RECEIPT DATE: 8/2/23 **ONSITE SEWAGE DISPOSAL SYSTEM** P 57/1981

APPROVAL DATE: 2/20/24 **PERMIT: New CONSTRUCTION** A _____

PROPERTY ADDRESS: 2060 Woodbine Road

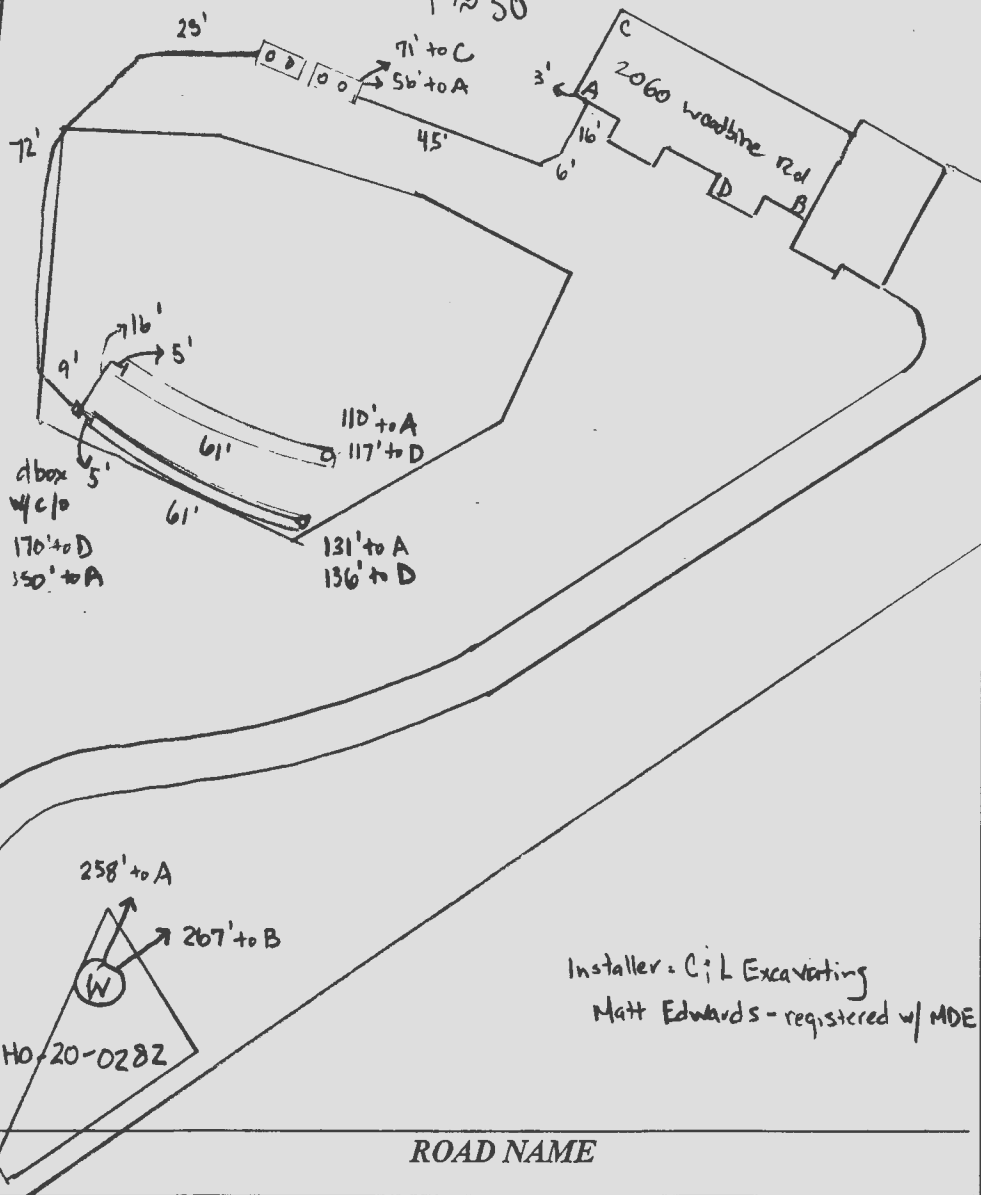
12/19/2022 - Contractor onsite for layout. Located plumbing location to come out of house, contractor stated they will be coming out higher than plan, tanks will have < 3' cover & there will be enough fall. While outside, contractor had dug inlet line & started laying pipe, told contractor not to do again. SDA corners - closest to SCA staked, trenches staked. Upper trench length @ 60' & lower @ 59'. Space between trenches 16"-18". Upper trench off contours by 1" or less, lower trench off contours by 2" or less. (S)

INSTALLATION: 12/20/23 - site inspection contractor onsite, trenches complete, snc made; sewer line complete. both the septic tank & pump tanks were installed, the pump tank only had a cure date of 2 days - not 7 days, requested that they not backfill the pump tank until we get spec from Back River, reinspect for FM's baffles, trenches @ 61' (x2), geotextile fabric in place, stone double washed, observation ports installed. (S) 12/21/23 - FM constructed from pump tank to dbox, 2" line, PSI 280, line turns down into the dbox (no baffle), 6" x 4" baffles on ST ok, ok to backfill, reinspect for P&A. (S) 12/21/23 - cure time of 2 days for the pump tank ok'd by J. Williams & M. Davis. (S) 2/20/24 - P&A ok (S)

P&A inspection 2/20/24

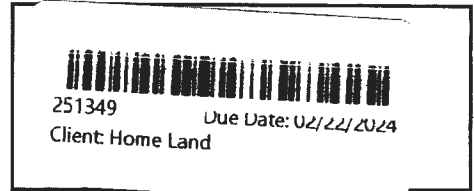
Conduit & junction box on post ~ 12" above grade
conduit runs over riser & under riser lid. -

patched w/
putty. (RM)
